**PROJECT NAME:** PINNACLE MONTESSORI ROCKWALL  
**EXISTING LEGAL DESCRIPTION:** LOT 5A, ROCKWALL BUSINESS PARK EAST  
**CASE NUMBER:** P2022-006  
**CURRENT OWNER:** BUFFALO COUNTRY PROPERTIES LLC,  
 ATTN: RAJESH MALVIYA  
 12050 RESEARCH ROAD, #9305  
 FRISCO, TX 75033  
**DEVELOPER:** SRC LAND BUILDING AND REAL ESTATE LLC  
 811 S. CENTRAL EXPRESSWAY, SUITE 306  
 RICHARDSON, TX 75080

MIS2025-005: Exception to the Residential Adjacency Standards at 950 E. Ralph Hall Parkway

## PLANNING AND ZONING COMMISSION MEMORANDUM

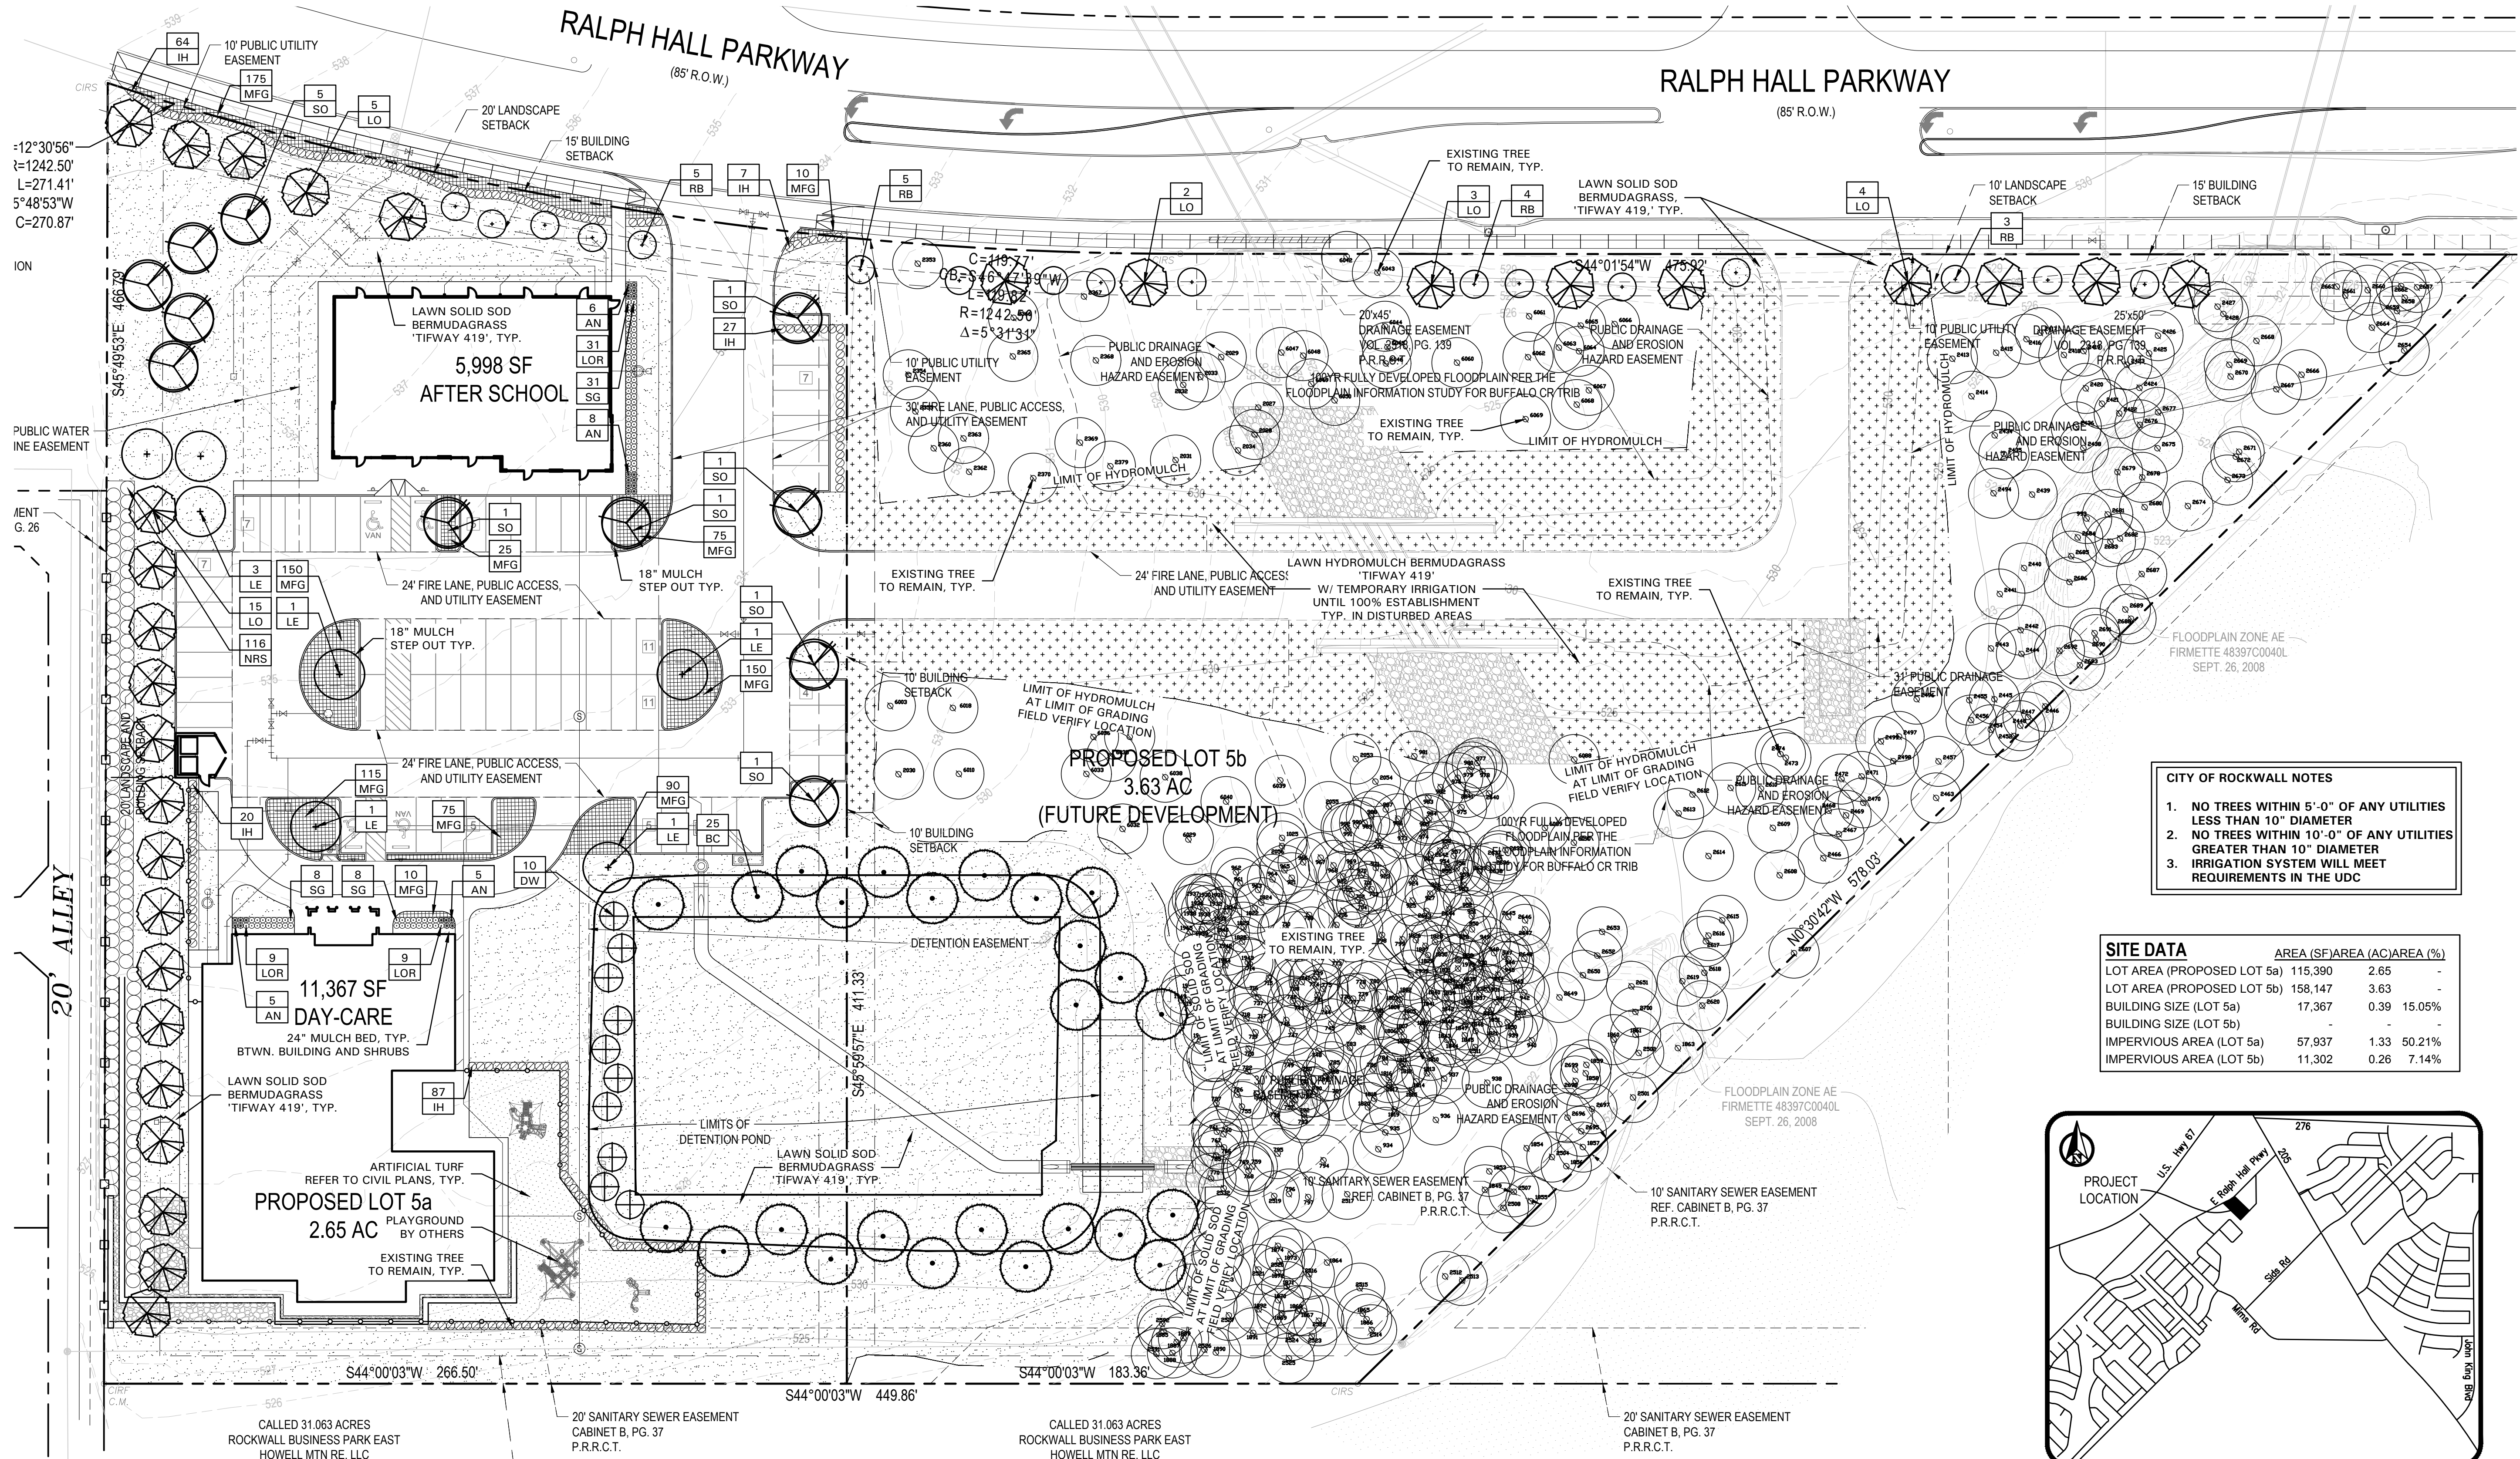
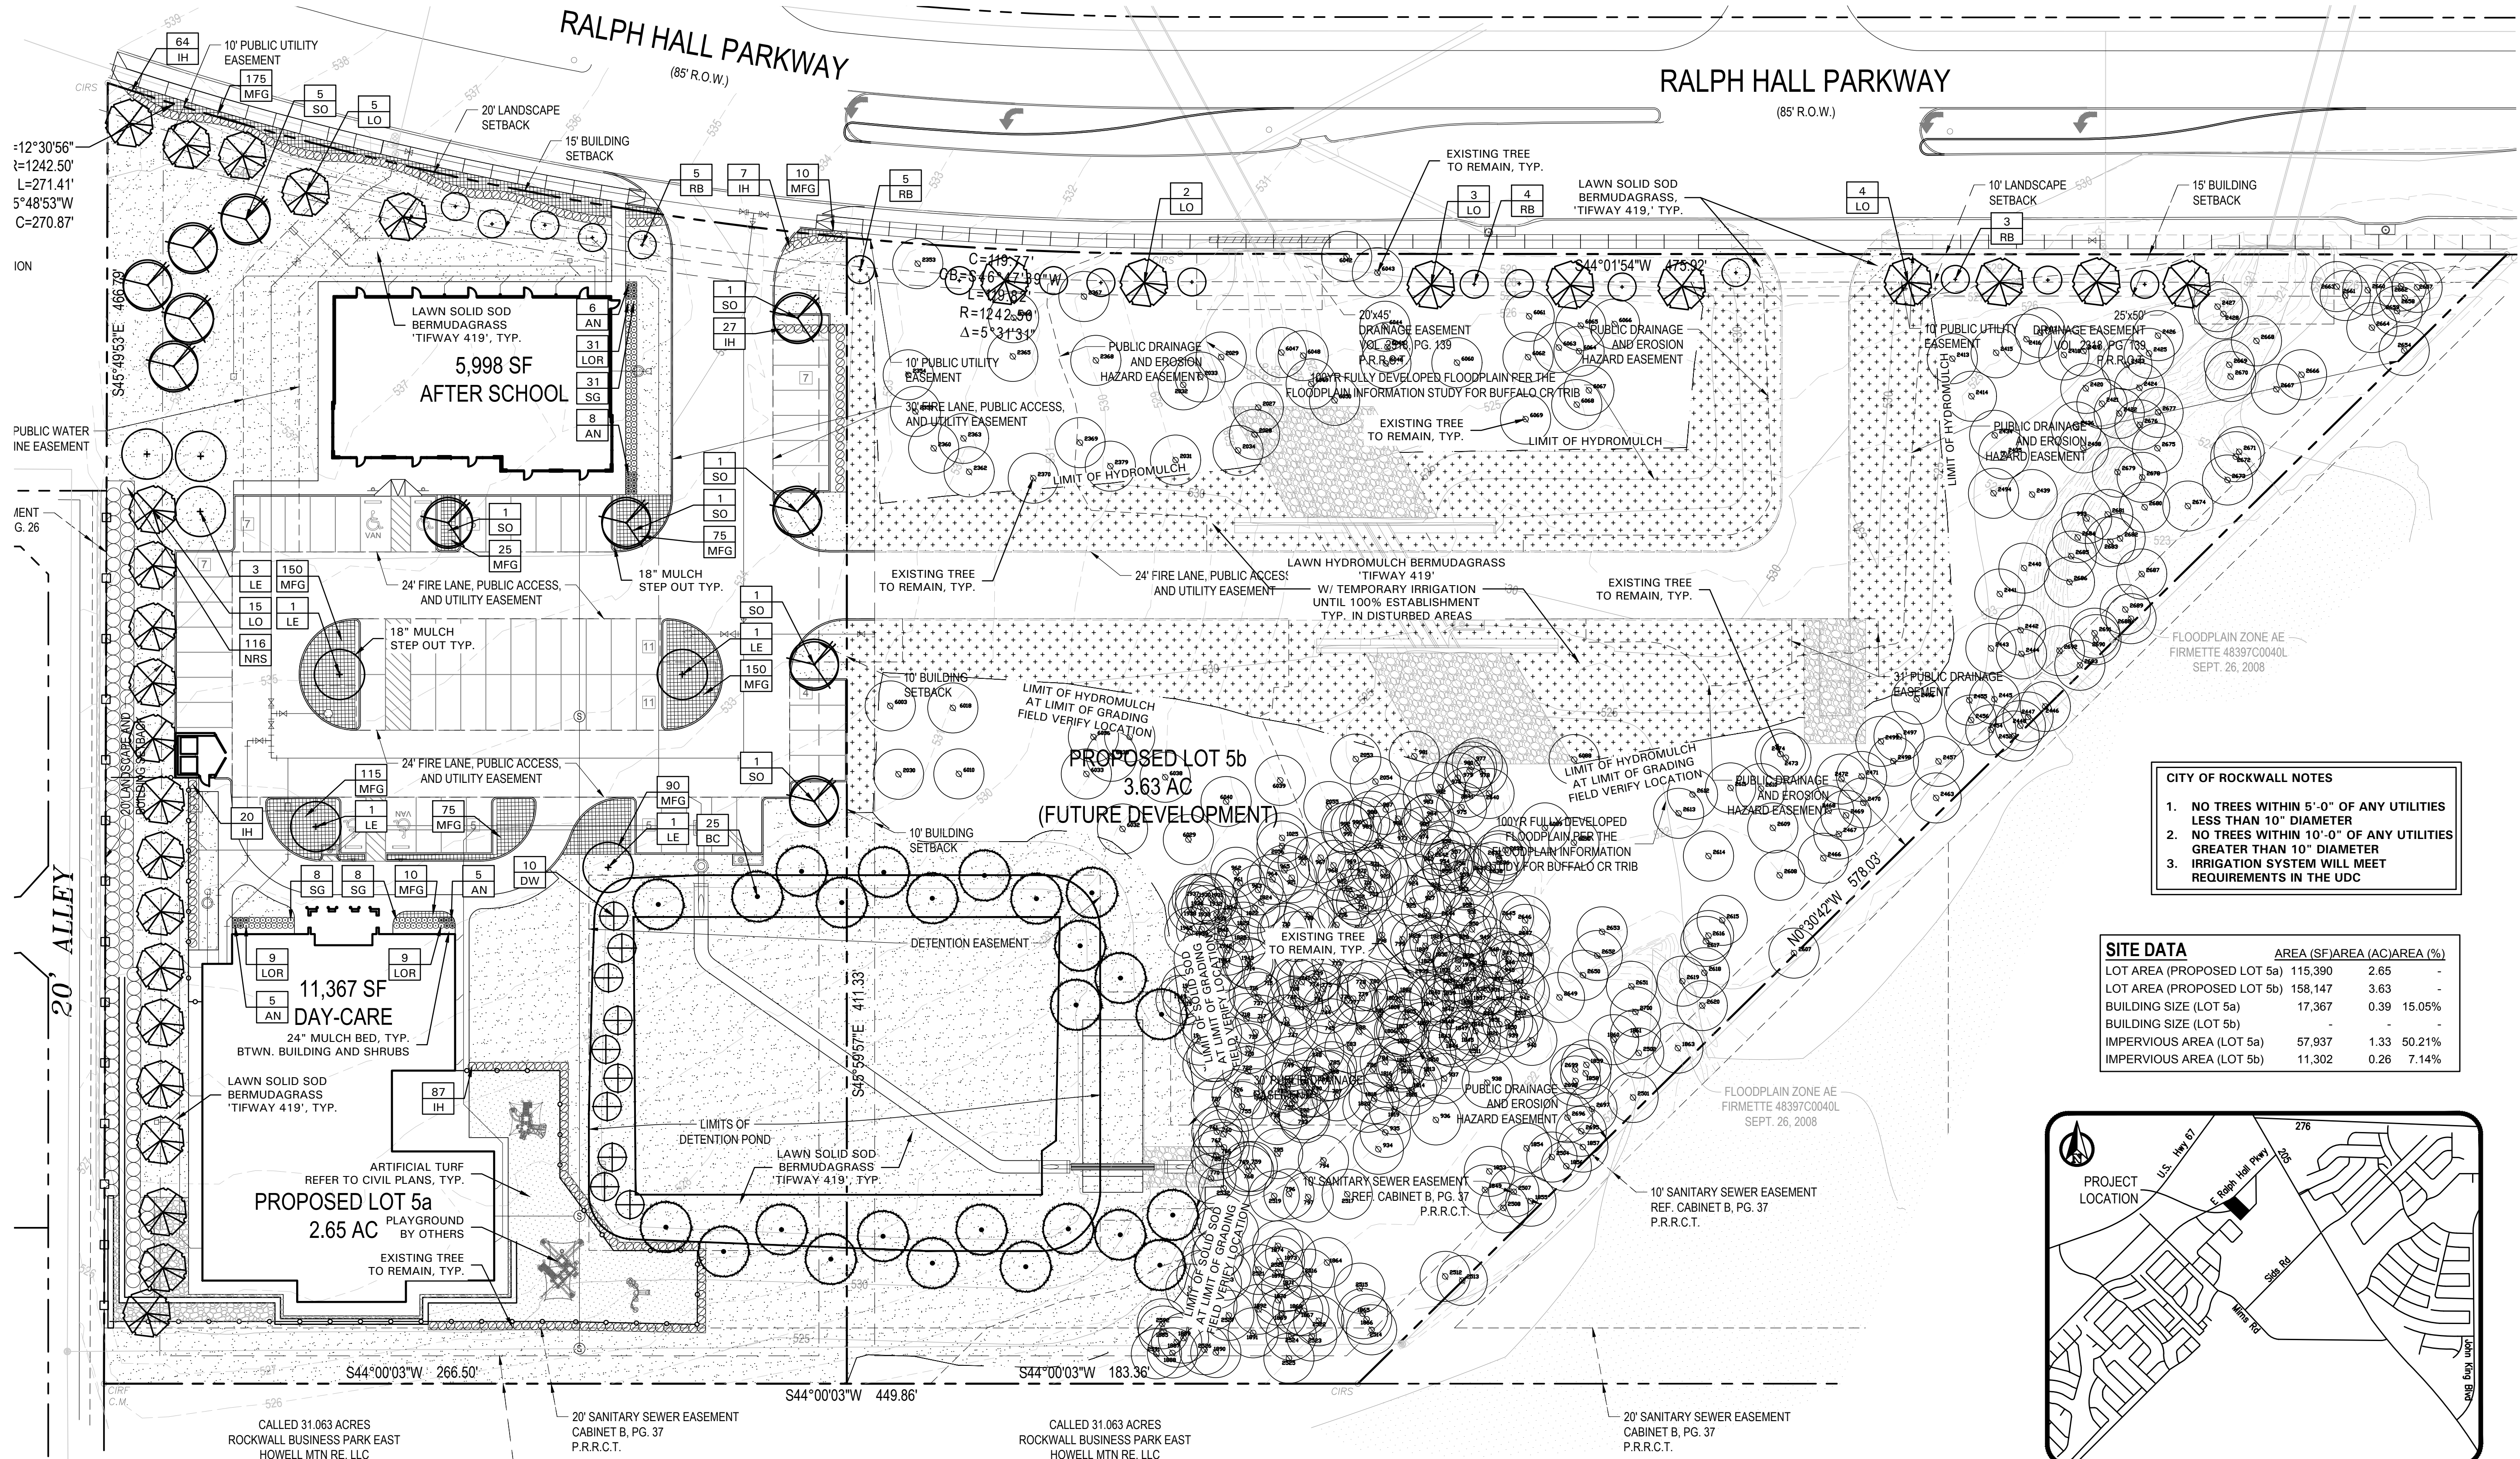
I.3 According to Subsection 05.02, Landscape Screening, of Article 08, Landscape and Fence Standards, of the Unified Development Code (UDC), "(a)ny non-residential or multi-family land use or parking area that has a side or rear contiguous to any residentially zoned or used property shall be screened with a masonry fence a minimum of six (6) feet in height with canopy trees planted on 20-foot centers." As an alternative the code does allow the Planning and Zoning Commission to consider the use of three (3) tiered landscaping along the adjacency. In this case, the applicant is providing three (3) tiered landscaping along the adjacency.

I.4 According to Subsection 09.01, Exceptions to the General Standards, "...an applicant may request the Planning and Zoning Commission grant an exception to the provisions contained in the Unified Development Code (UDC) where unique or extraordinary conditions exist or where strict adherence to the technical requirements of the Unified Development Code (UDC) would create an undue hardship." To request an exception the code goes on to require that a minimum of two (2) compensatory measures be provided for each exception requested. The purpose of the compensatory measures is to try to directly off-set the impact of requested exception. In this case the applicant has not provided any subsequent compensatory measures.

1.5 According to Subsection 08.02, General Fence Standards, "PVC mesh (i.e. tennis court mesh/windscreen) or other materials or appurtenances (e.g. slats, bamboo, mesh netting, fake or artificial plants or patterned material, signage, banners, etc.) intended to provide screening that are affixed to wrought iron, decorative metal, chain-link or semi-transparent fencing shall be prohibited."
